TECHNICAL BULLETIN
Bell Helicopter **TEXTRON**

No. 214-02-92

MODEL AFFECTED: 214B/B-1

SUBJECT: INTRODUCTION OF P/N 214-001-133-103
COLLAR AND MODIFICATION OF EXISTING P/N
214-001-133-001 COLLAR

FIGURE 1

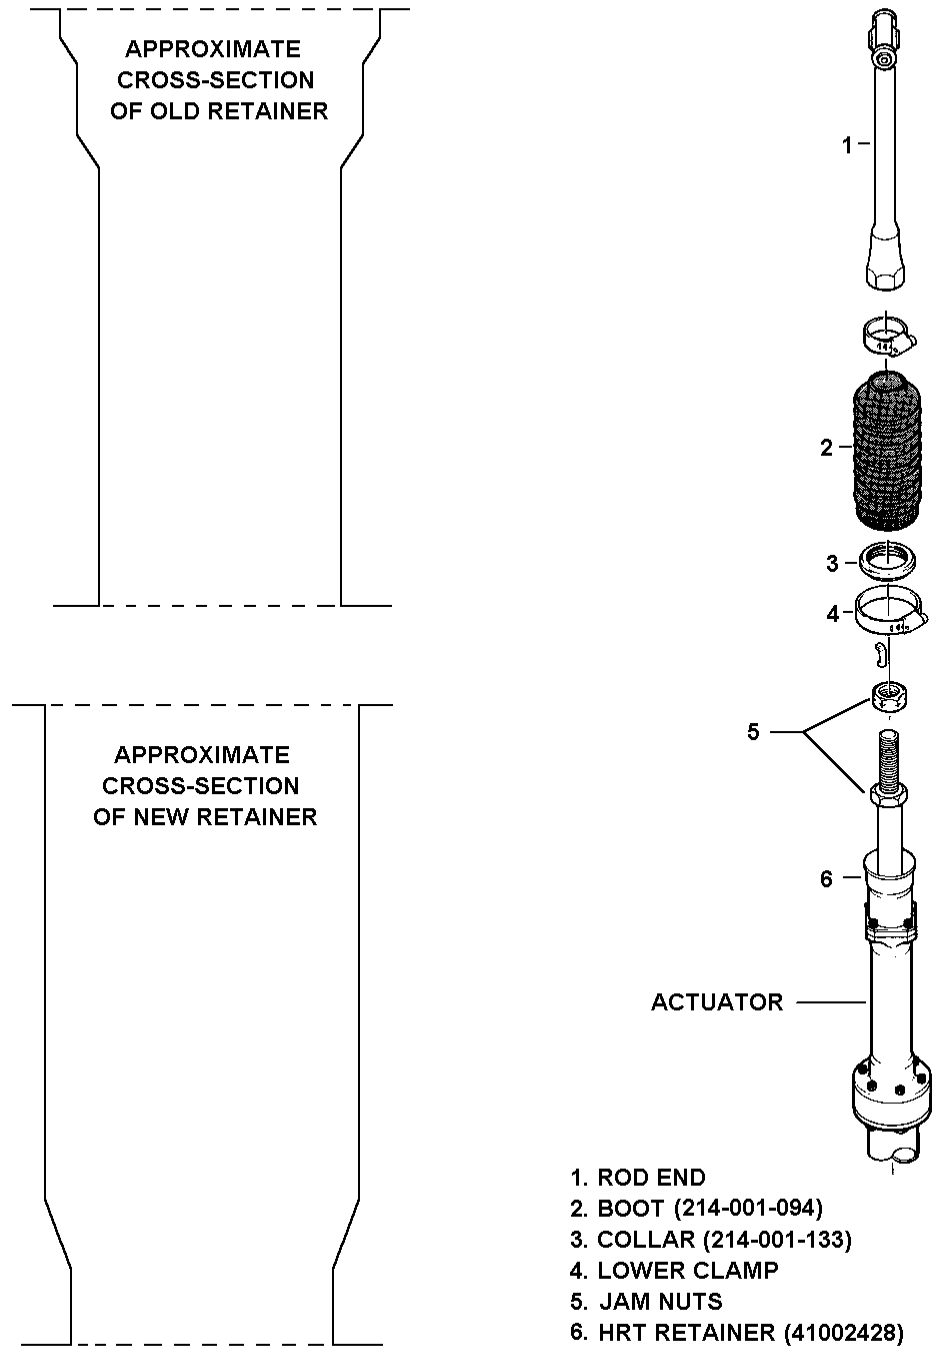
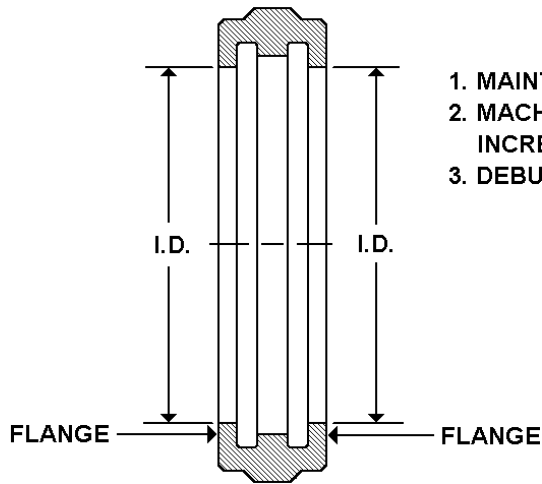
1. Refer to Figure 1 to determine differences between the old P/N 41002428 retainer and the new P/N 41002428 retainer. The P/N 214-001-133-103 Collar supersedes and replaces the -001 Collar.
2. Existing P/N 214-001-133-001 Collars may be field modified into the -103 configuration to fit new retainers as follows (see Figure 2):
 - a. Maintain the split line gap of 0.060 to 0.065 inches during the following steps.
 - b. Using a suitable method, lightly scribe, or mark, the new diameter on both outer surfaces of the collar flanges.
 - c. Using a suitable tool increase the inner diameter of both flanges evenly to the new diameter dimension. Deburr edges.

3. Refer to Figure 1. When installing the P/N 214-001-094 Boot (Item 2) over the P/N 214-001-133 Collar (Item 3) and securing with the clamp (Item 4), the collar must be free to rotate after the clamp is tightened.

FIGURE 2

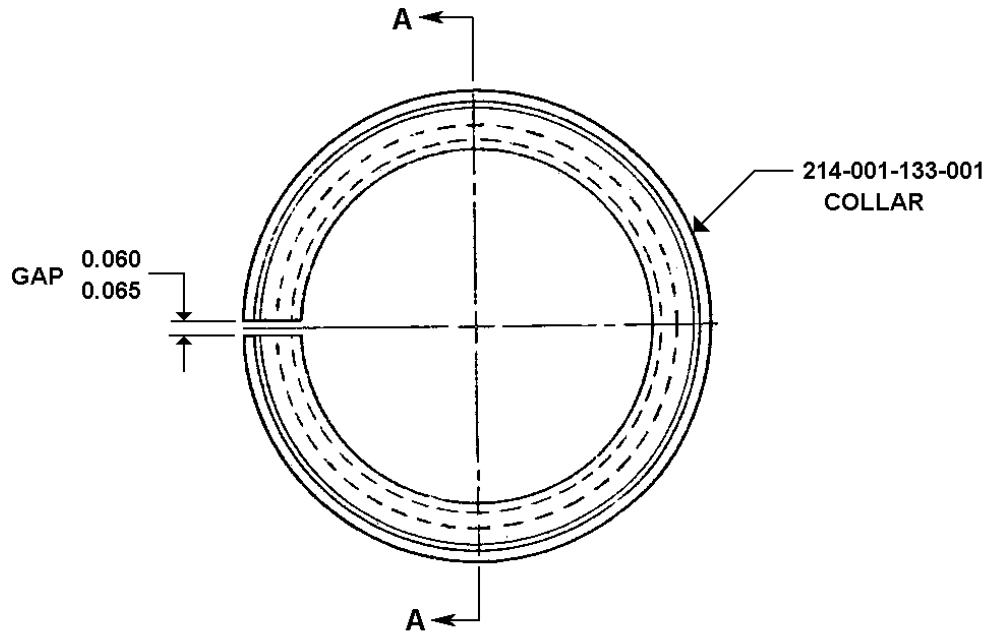
1. MAINTAIN 0.060 TO 0.065 INCH GAP ON COLLAR.
2. MACHINE I.D. OF BOTH FLANGES EVENLY TO INCREASE DIAMETER TO 2.060 +/- 0.010 INCH.
3. DEBURR FLANGE EDGES.
